## Product Change Notification / SYST-21QLVX434

ERRATA - dsPIC33EPXXXGM3XX/6XX/7XX Family Silicon Errata and Data Sheet Clarification Document Revision

- 1) Adds silicon issue 44. Module: "I2C".
- 2) Add data sheet clarifications 24. Module: "Electrical Characteristics", 25. Module: "Pin Diagrams", 26. Module: "Pin Diagram" and 27. Module: "Special Features".

## dsPIC33EPXXXGM3XX/6XX/7XX Family Silicon Errata and Data Sheet Clarification

**FIGURE 1: TIMING DIAGRAMS FOR CENTER-ALIGNED AND EDGE-ALIGNED MODES**

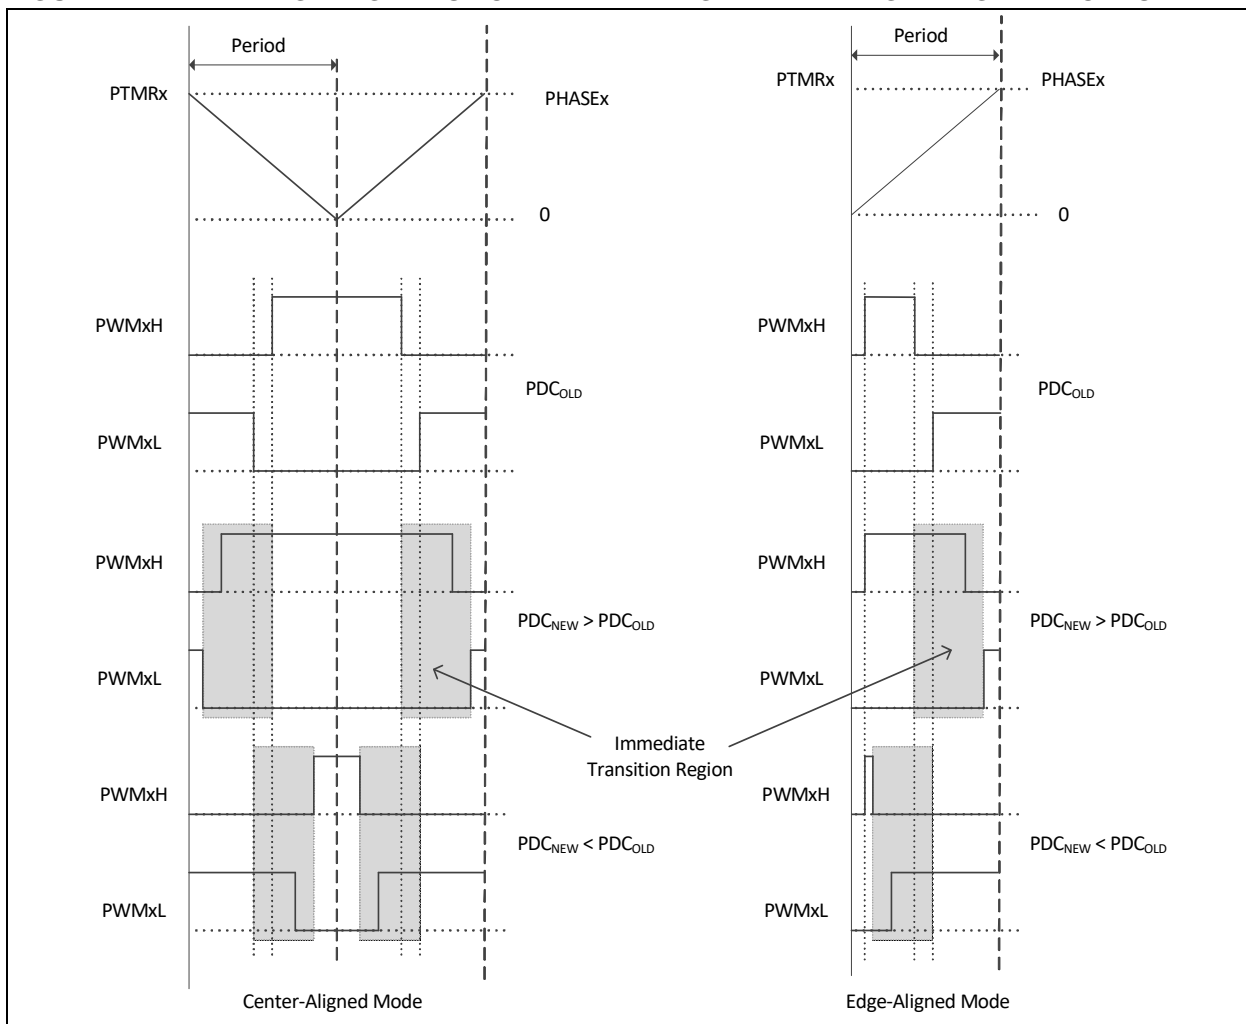
The PWM generator may not assert dead time on the edges of transitions. This has been observed when all of the following conditions are present:

- The PWM generator is configured to operate in Complementary mode with Independent Time Base (ITB) or master time base;
- Immediate update is enabled; and
- The value in the PDC register is updated in such a manner that the PWMxH and PWMxL outputs make an immediate transition.

In Figure 1, if the duty cycle write occurred in the shaded box, then PWMxH and PWMxL will make an immediate transition without dead time.

None.

In most applications, the duty cycle update timing can be controlled using the TRIGx trigger, or Special Event Trigger, such that the above mentioned conditions are avoided altogether.

**FIGURE 2: PWM GENERATOR TIMING DIAGRAM**

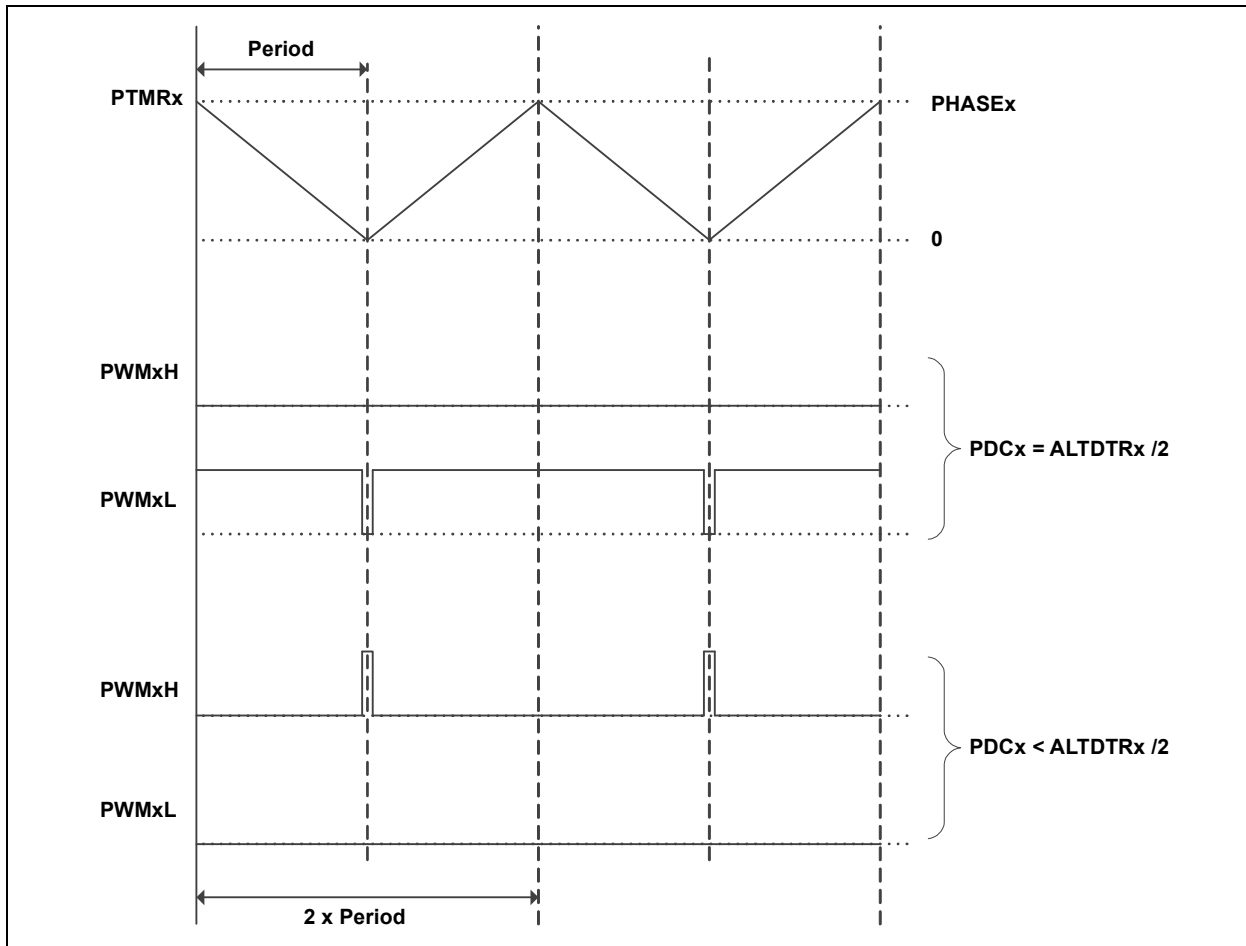
In Center-Aligned Complementary mode with Independent Time Base, if the value in the PDCx register is less than one-half the value in the ALTDTRx register, the PWM generator will force the PWMxL to low, and on the PWMxH, generates pulses of a width less than twice the dead time, as shown in Figure 2.

Include a software routine to ensure that the duty cycle value written to the PDCx register is at least one-half of the value in ALTDTRx. Example 1 shows one method, with PDCtemp representing the variable which has the value to be written to the PDCx register. Alternatively, for duty cycle values less than half the desired dead-time value, zero out the ALTDTRx register or dynamically reduce the value in the ALTDTRx register, such that ALTDTRx is always equal to  $2 * PDCx$ , as shown in Example 2.

Altdtr_by2 = ALTDTRx / 2;
if (PDCtemp < Altdtr_by2)
{
PDCx = Altdtr_by2;
}
else
{
PDCx = PDCtemp;
}

**FIGURE 3:**

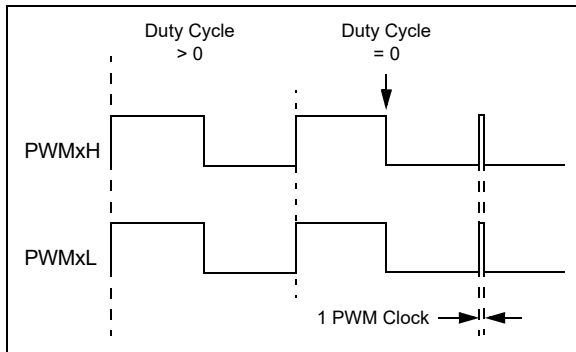
In certain output modes, the PWMx module produces a pulse glitch of one PWM clock in width (Figure 3). This has been observed only when all of the following are true:

- Either Redundant or Push-Pull Output mode is selected (IOCONx[11:10] = 10 or 01);
- Immediate Update is disabled (PWMCONx[0] = 0); and
- The value of the current Duty Cycle register (either the PDCx or MDC register, as determined by PWMCONx[8]) is updated to zero from any non-zero value.

The pulse glitch has been observed to occur at the beginning of the following PWM boundary period.

If the application requires a duty cycle of zero, two possible work arounds are available.

1. Use the PWM overrides to force the output to a low state, instead of writing a '0' to the Duty Cycle register. When using this method, the PWM override must be disabled when the duty cycle is a non-zero value. If output override synchronization is configured to occur on CPU clock boundaries (IOCONx[0] = 0), enabling and disabling the override must be timed to occur as closely as possible to the PWM period boundary.
2. Configure the module for Immediate Update (PWMCONx[0] = 1) before enabling the module. In this mode, writes to the Duty Cycle register have an immediate effect on the output. As with the previous work around, writes to the Duty Cycle register must be timed to occur as close to the PWM period boundary as possible in order to avoid distortion of the output.

**FIGURE 4:**

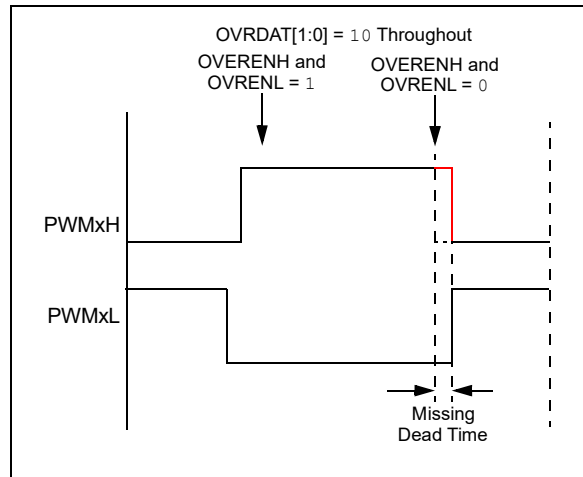
In Complementary Output mode, the expected dead time between transitions of the PWMxH and PWMxL outputs may not be asserted when the following occurs:

- Output override synchronization is configured to occur on the CPU clock boundary (IOCONx[0] = 0);
- Both PWMxH and PWMxL overrides are enabled prior to the event (OVRENH and OVRENL are both '1'), and
- Both overrides are disabled (OVRENH and OVRENL are both '0') at the instant the dead time should be asserted (Figure 4).

This has been observed in both Center-Aligned and Edge-Aligned modes.

None.

FIGURE 5:

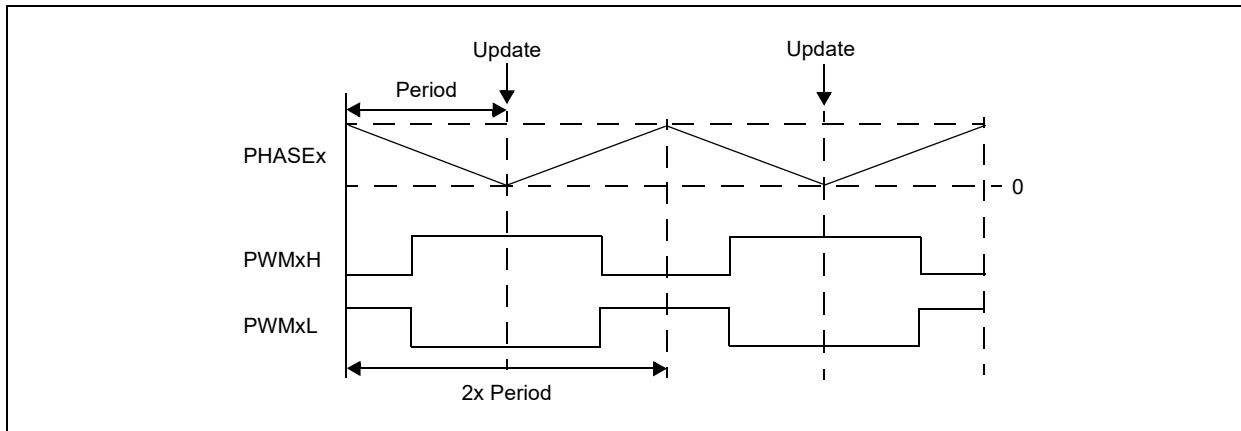
In Center-Aligned Complementary mode with Independent Time Base, updates to the PHASEx register take effect in the middle of a Center-Aligned PWM cycle, as shown in Figure 5. This occurs only when the Immediate Update feature is disabled (IUE = 0). If Immediate Update is enabled (IUE = 1), the PHASEx register updates will take effect immediately.

None.

FIGURE 6:

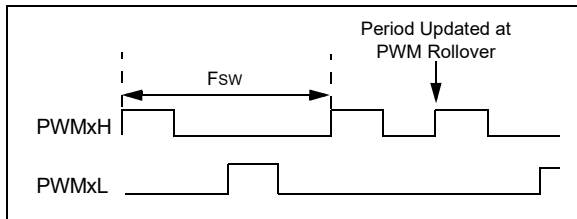
When the PWM module is configured for Push-Pull mode (IOCONx[11:10] = 10) with the Enable Immediate Period Update bit enabled (PTCON[10] = 1), a write to the Period register that coincides with the period rollover event may cause the push-pull output logic to produce back-to-back pulses on the PWMx pins (Figure 6).

Ensure that the update to the PWM Period register occurs away from the PWM rollover event by setting the EIPU bit (PTCON[10] = 1). Use either the PWM Special Event Trigger (SEVTCMP) or the PWM Primary Trigger (TRIGx) to generate a PWM Interrupt Service Routine (ISR) near the start of the PWM cycle. This ISR will ensure that period writes do not occur near the PWM period rollover event.

**FIGURE 7: SIMPLIFIED BEHAVIOR**

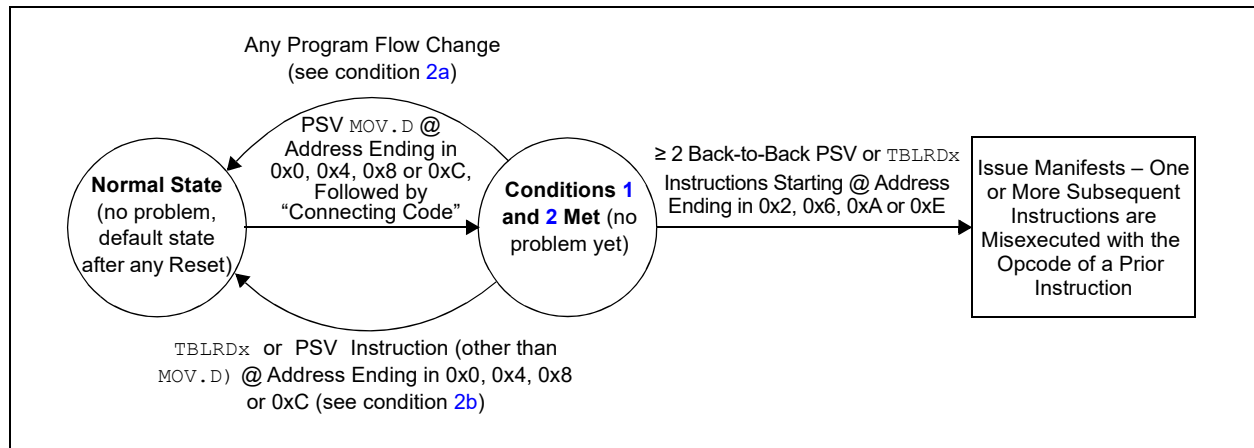
3.	≥ 2 back-to-back PSV or <code>TBLRDx</code> instructions are executed (following the code of condition 2), where the first of the back-to-back instructions is located at an address ending in 0x2, 0x6, 0xA or 0xE.

[Figure 7](#) provides an example of the effective behavior.

1. All instances of PSV `MOV.D` can be replaced with two PSV `MOV` instructions instead. Non-PSV `MOV.D` instructions acting on RAM/SFRs do not need to be modified; or
2. If not already present, a program flow change instruction (such as `BRA $+2`) can be inserted above back-to-back data Flash read sequences; or
3. Back-to-back data Flash read instruction sequences can be broken up by inserting a non-Flash read instruction (such as a `NOP`), in between the Flash read instructions; or
4. The alignment of the code can be shifted to avoid the required opcode location addresses.

C code built with MPLAB® XC16 Compiler Version 1.32, or later, implements the work around by default. However, if the application uses Assembly language routines, these should be manually modified to implement the work around. Additionally, if precompiled libraries are used, these should be built with XC16 Version 1.32 or later. For additional information, please visit: [www.microchip.com/erratum\\_psrds\\_psrds](http://www.microchip.com/erratum_psrds_psrds)

## 64-Lead Plastic Quad Flat, No Lead Package (MR) – 9x9x0.9 mm Body with 5.40 x 5.40 Exposed Pad [QFN]

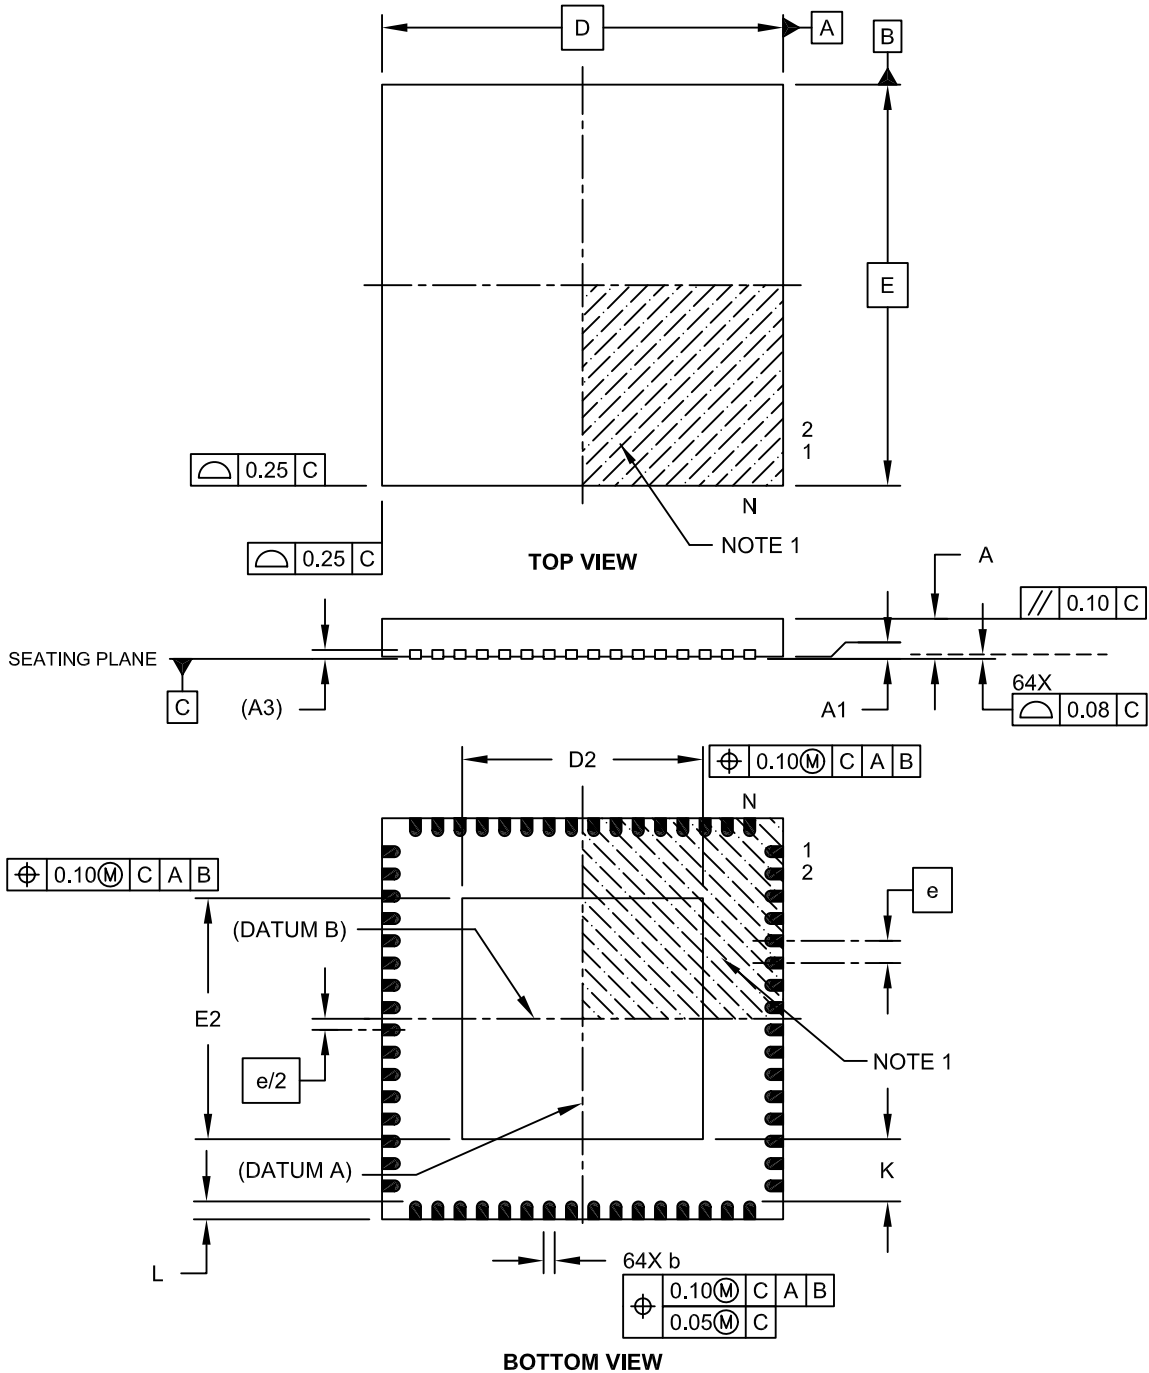
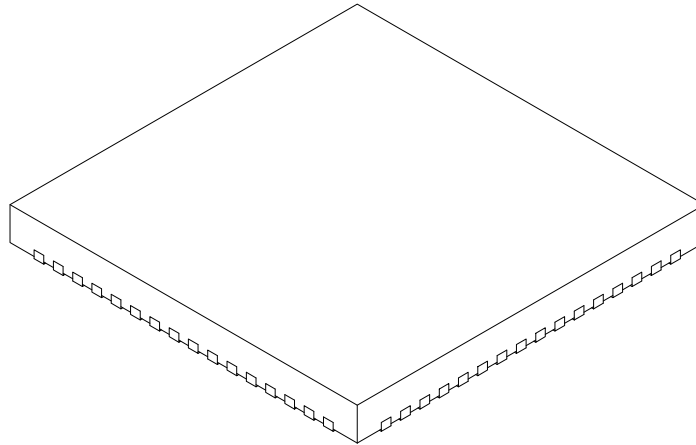
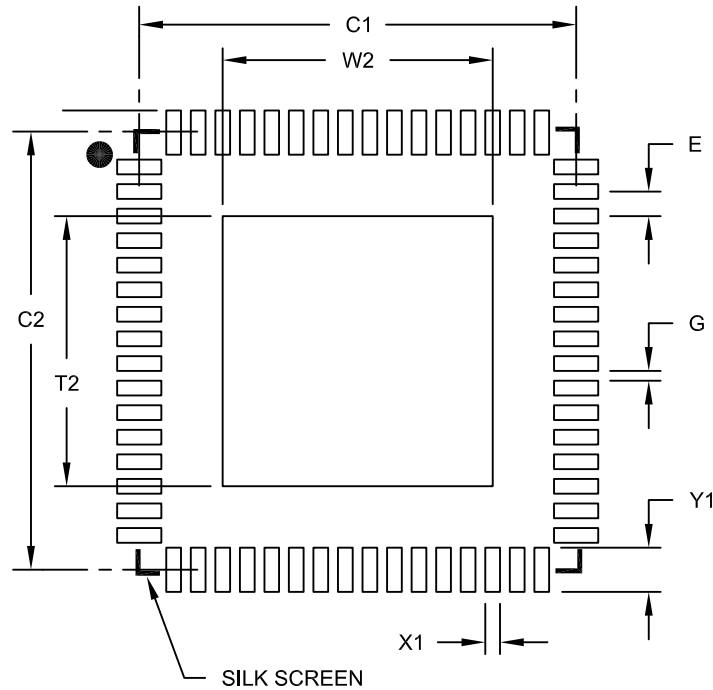
In the “*dsPIC33EPXXXGM3XX/6XX/7XX Family Data Sheet*”, **Section 35.2 “Package Details”**, dimensions for the 64-Lead Plastic Quad Flat, No Lead Package (MR) – 9x9x0.9 mm Body with 7.15 x 7.15 Exposed Pad [QFN] is mentioned. However, the dsPIC33EPXXXGM3XX/6XX/7XX family devices are not available in this package.

The dsPIC33EPXXXGM3XX/6XX/7XX family devices are available in the 64-Lead Plastic Quad Flat, No Lead Package (MR) – 9x9x0.9 mm Body with 5.40 x 5.40 Exposed Pad [QFN], and the package dimensions are shown on the following pages.
